New Goddard School 193 Central Avenue, Milton, Massachusetts

**APPLICATION TO AMEND SITE PLAN APPROVAL dated July 23, 2020
193 Central Avenue, Milton**

AMENDMENT APPLICATION: Application to Amend Site Plan for 193 Central Avenue, Milton
(New building) dated 9.24.2021

SITE PLAN: "Site Plan, The Goddard School, 193 Central Avenue, Milton,
Massachusetts", by Williams & Sparages, 189 North Main Street,
Suite 101, Middleton, MA 01949 dated 9.7.2021

PHOTOMETRIC PLAN AND LIGHTING SPECIFICATIONS

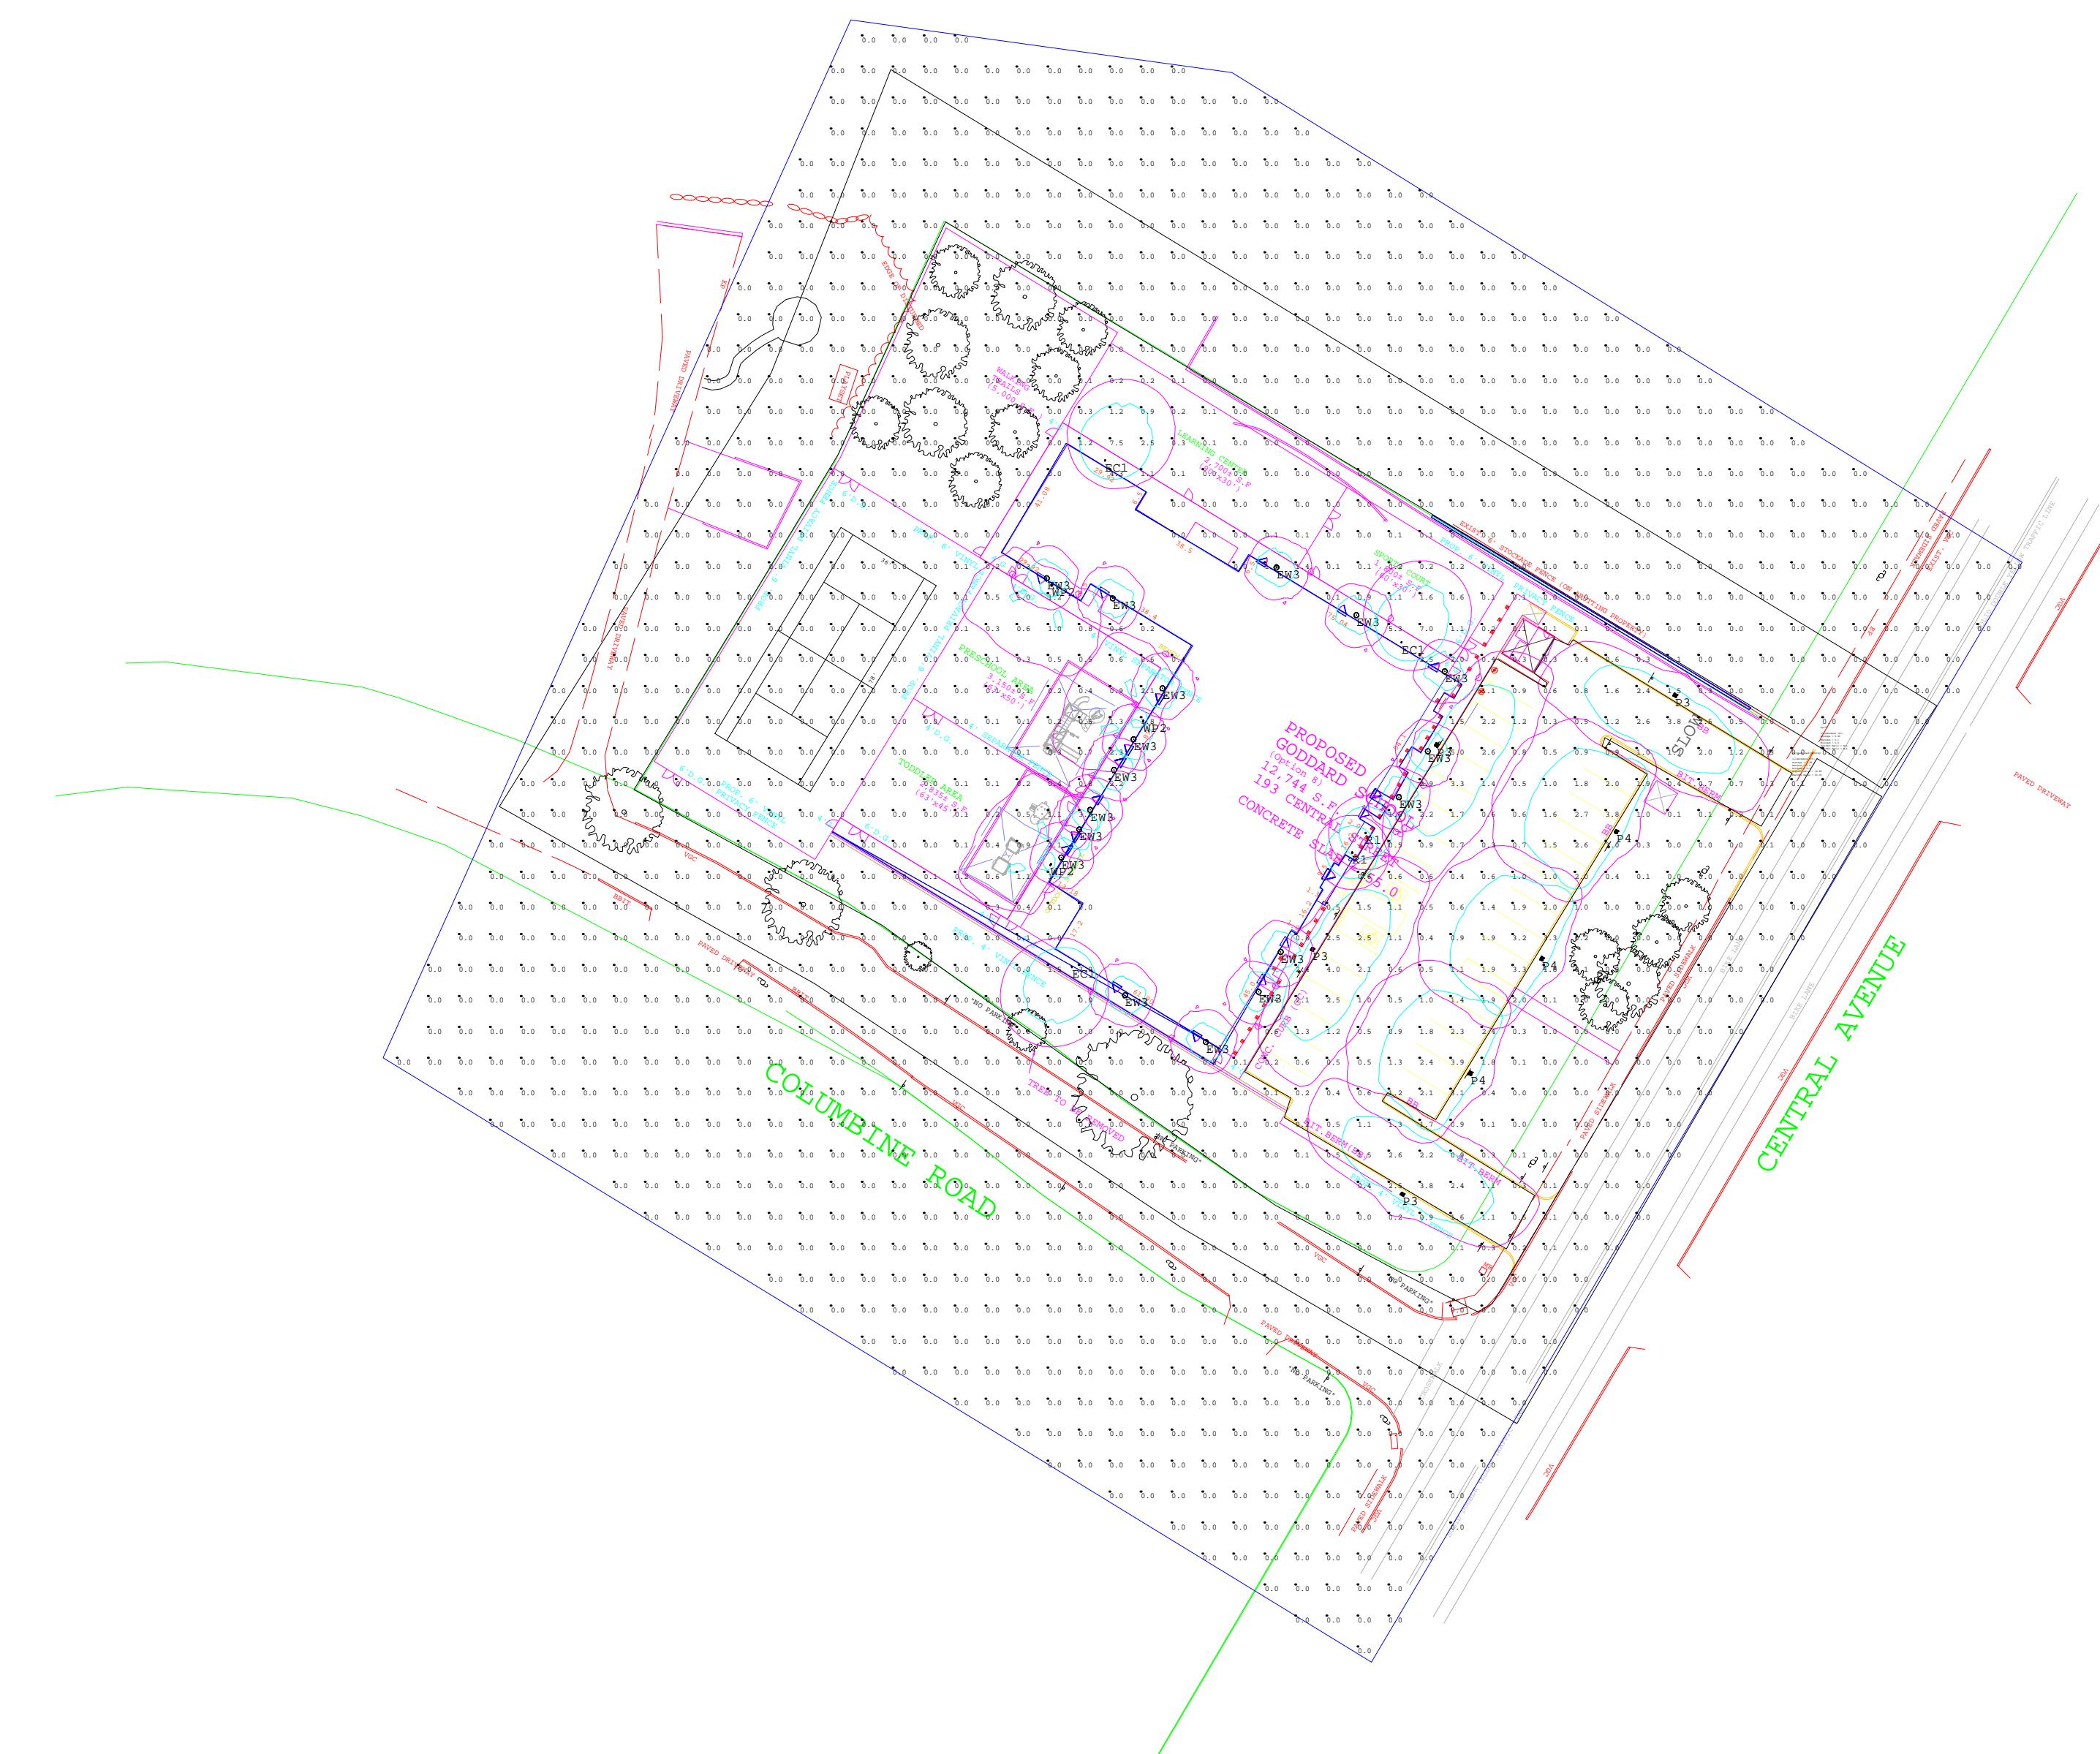
18. LIGHTING PLAN: a new lighting plan, specifications, and photometrics have been provided as Exhibit L. The photometric plan showing lighting locations is also included as Sheet 10 in the site plan. As with last year's plan, the lighting is dark sky compliant and shields abutting properties from lighting overspill; all lighting will be on a timer to go off about an hour after school closes at 6 p.m.; and any light poles are no higher than 10 feet. As in the approved site plan, there will be security lighting with adjustable angles on the building for after closing that is activated by motion sensors. The angle of the security lighting can be adjusted to ensure that no lighting shines towards neighboring property.
